SIMILAR TO LEFT SIDE ASSEMBLY

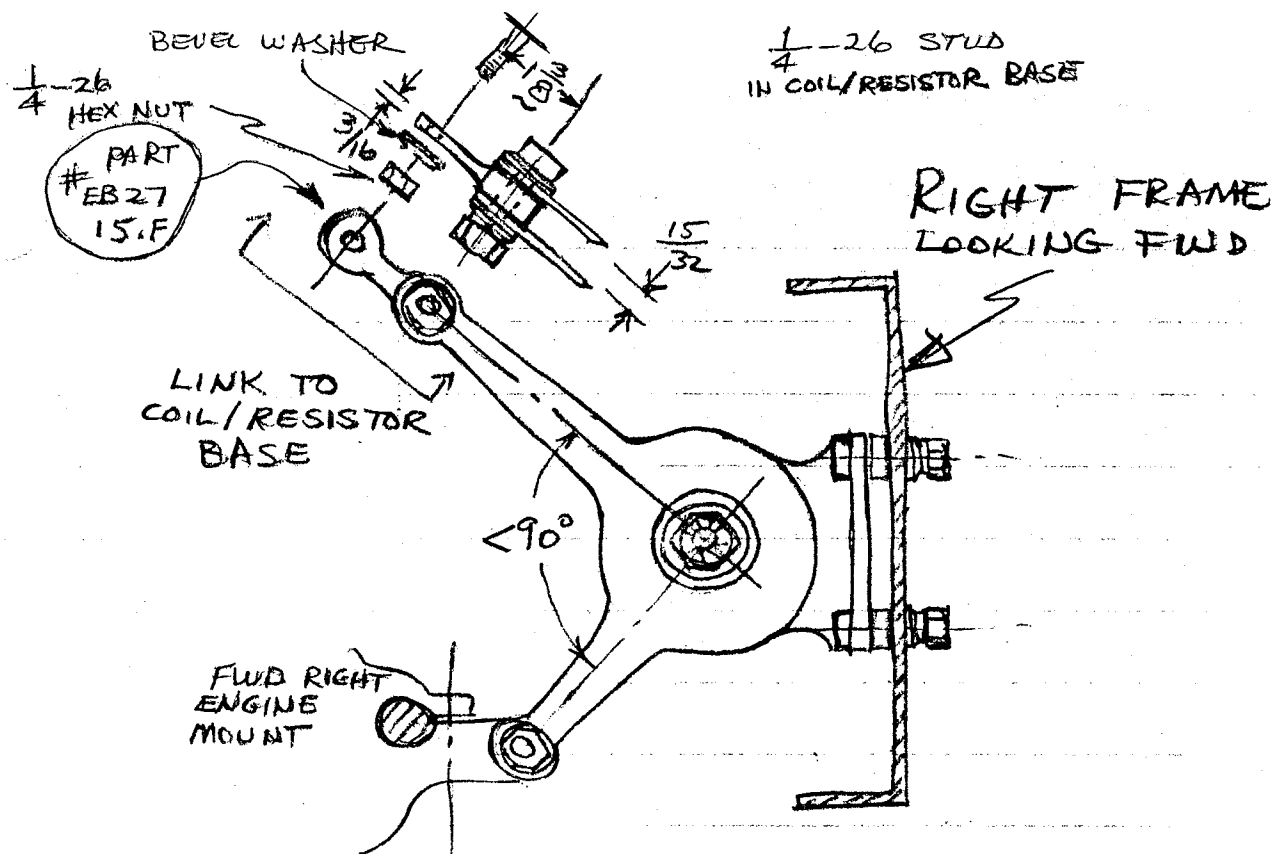
- ① HAS ONE $\frac{1}{8}$ " SPACER BETWEEN MOUNTING DISC & FRAME (NEED TWO LEFT SIDE SHOULD PROBABLY HAVE $\frac{1}{8}$ " SPACERS INSTEAD OF TWO $\frac{1}{16}$ SPACERS @ EACH MOUNTING BOLT,
- ② ONE BEVELED WASHER MISSING FROM ASS'Y ARM - REPLACE WITH FLAT WASHER.
- ③ ALL FRICTION SURFACES ARE BARE STEEL; OTHERWISE PAINT ARMS / BRACKETS / SPRINGS BLACK
